APPLICATION NO.	FILING DATE	FIRST NAMED INVENTOR	ATTORNEY DOCKET NO.	CONFIRMATION NO.
09/413,348	10/06/1999	NORIHISA FUKUTOMI	Q56091	1912

# Office Action Summary

## **DETAILED ACTION**

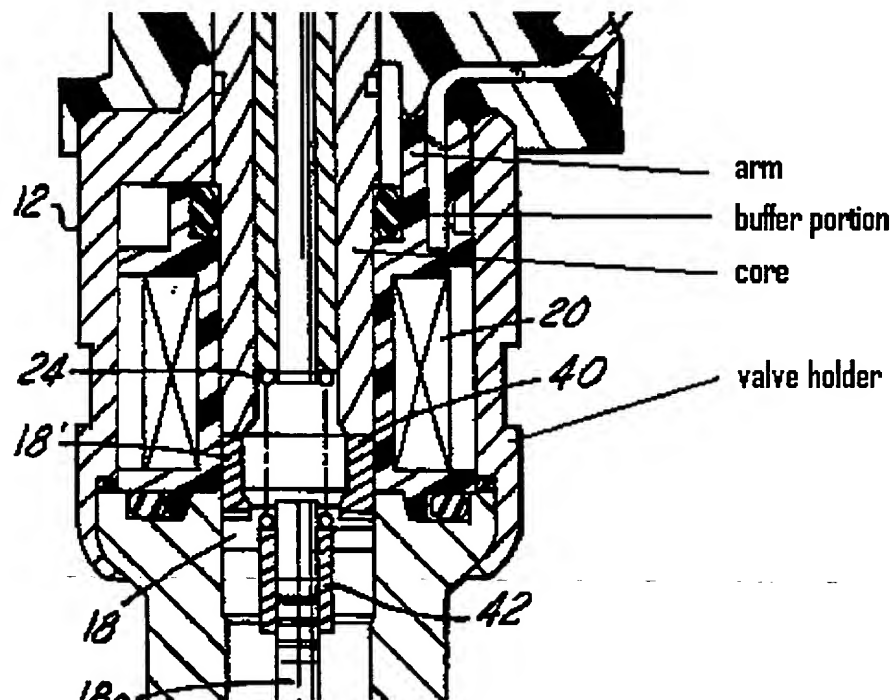
Claims 6 and 8 recite "[a] fuel injection valve for opening and closing a needle by driving an armature with a solenoid comprising". It is uncertain whether applicant is claiming a combination of a fuel injection valve, a needle, an armature and a solenoid or the subcombination of a fuel injection valve. It appears that the fuel injection valve comprises a needle, an armature and a solenoid. Additionally, does the fuel injection valve comprise a means for damping or does the solenoid comprise a means for damping?

Claims 7 and 9 recite "[a] fuel injection valve for opening and closing a needle by driving an armature with a solenoid, comprising". It is uncertain whether applicant is claiming a combination of a fuel injection valve, a needle, an armature and a solenoid or the subcombination of a fuel injection valve. It appears that the fuel injection valve comprises a needle, an armature and a solenoid.
